**NRC Staff Request for Additional Information
on the
Draft Basis for Section 3116 Determination and
Associated Performance Assessment
for the
H-Area Tank Farm at the Savannah River Site**

Figure 1. Illustration of the as-modeled annular waste and fast pathway in Tanks 9H and 10H

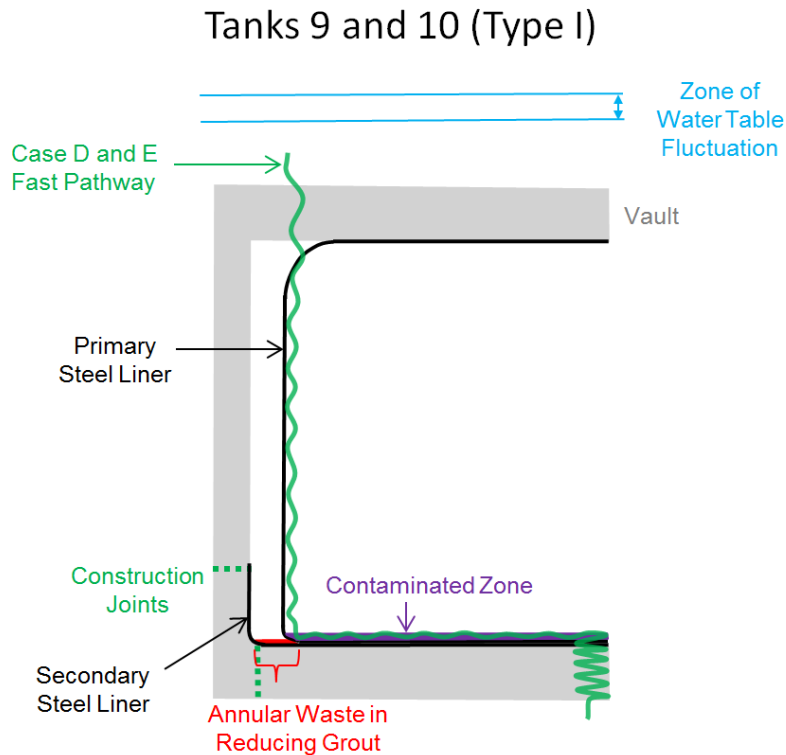
In DOE's PORFLOW[®] model (see Figure 1), the annular waste in Tanks 9H and 10H is loaded within the bottom of the annular reducing grout. Loading of the annular waste into the bottom of the reducing grout in DOE's PORFLOW[®] model assigns K_d values associated with reducing grout. For redox-sensitive radionuclides, this appears to significantly limit mobility even though this waste is assumed to be highly mobile. In addition, the preferential pathway represented in cases B-E does not intersect the annular waste in Tanks 9H and 10H. Based on operational experience, NRC staff is concerned that groundwater in-leakage into the annular region could occur and that the associated risk with this scenario is not adequately addressed within the Performance Assessment.

Figure 2. Illustration of the as-modeled sand pad waste and fast pathway in Tanks 14H and 16H

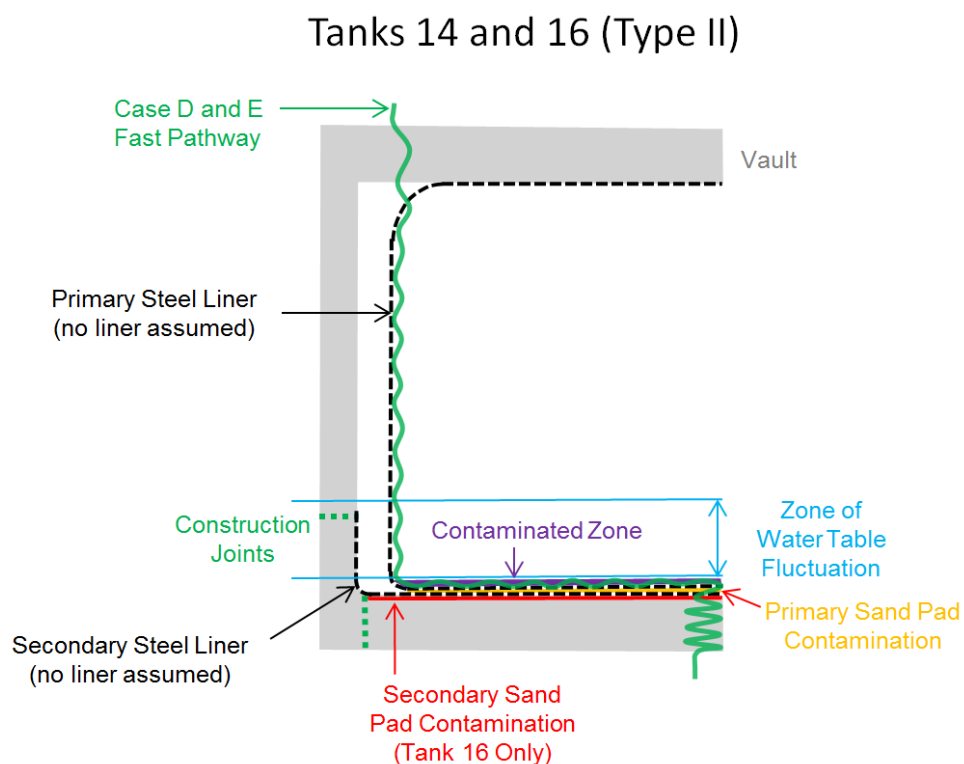
addition, the HTF Performance Assessment does not discuss the extent of diffusion out of the sand pads and into the adjacent cementitious materials.

It appears that a potentially significant fraction of the highly radioactive radionuclide inventory is diffusing into the basemat and/or contaminated zone prior to release. Diffusion of radionuclides out of the primary and secondary sand pads is facilitated in the model by a high diffusion coefficient, large concentration gradient, small diffusion length, assumption of no steel liners, and a delay in the flow through the fast pathway due to closure cap. Although the steel liners are not assumed to not be intact for Tanks 14H and 16H due to the large number of leak sites, the steel liner could still act as a partial barrier to diffusion. Also, the delay in flow through the preferential pathway, due to the assumption of flow being limited to infiltration through the closure cap, may overestimate the amount of time radionuclides can diffuse out of the sand pads if groundwater in-leakage were to occur.

short-lived radionuclides (e.g., cesium-137 and strontium-90) that decay prior to significant flow occurring in the fast flow path. DOE should also provide discussion regarding the fraction of the highly radioactive radionuclides (e.g., technetium, plutonium, and neptunium) that diffuse out of the sand pads and into the grout or basemat.
